## **ADDENDUM NO. FOUR**

23 MARCH 2020

**PROJECT TITLE: JACKSONVILLE STATION**  
**1300 NORTH MARINE BOULEVARD/HWY 17 NORTH**  
**JACKSONVILLE, NORTH CAROLINA**  
**JACKSONVILLE PROJECT NO. BP19-00002283**  
**HRA COMMISSION #189518.00**

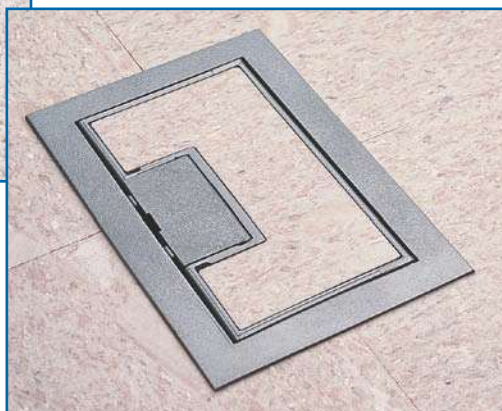
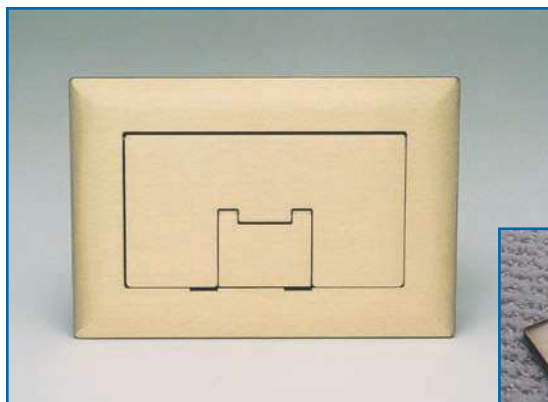
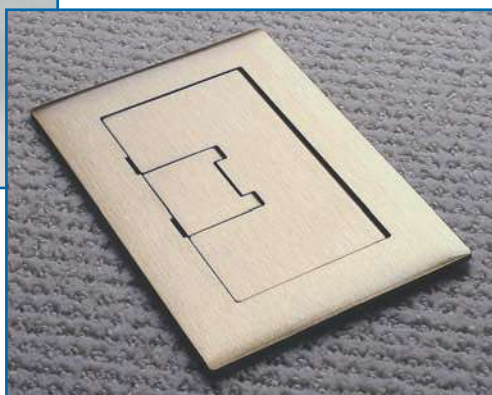
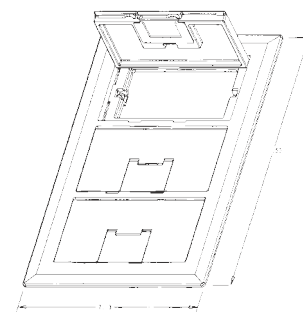
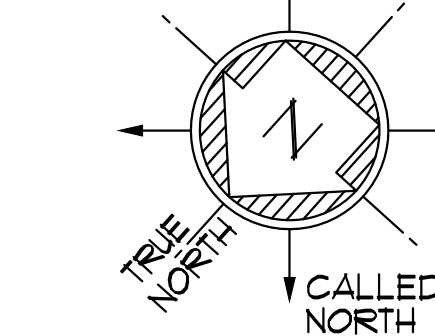
10. Drawing E 2.2 B indicates power for admin portion of building this drawing shows 6 floor boxes 4 of these have a data beside them the electrical legend on drawing E 0.1 only indicates a symbol for a floor box with a duplex receptacle.  
Are these data outlets to be in the floor or are they in ceiling?  
If in the floor are, they in same floor box or separate floor box have design team provide information on floor box for data

See the attached "Floor Box Submittal.pdf" for our understanding of the two-gang floor box that was the design intent. This is a submittal from a past project, and specification equals are welcomed.
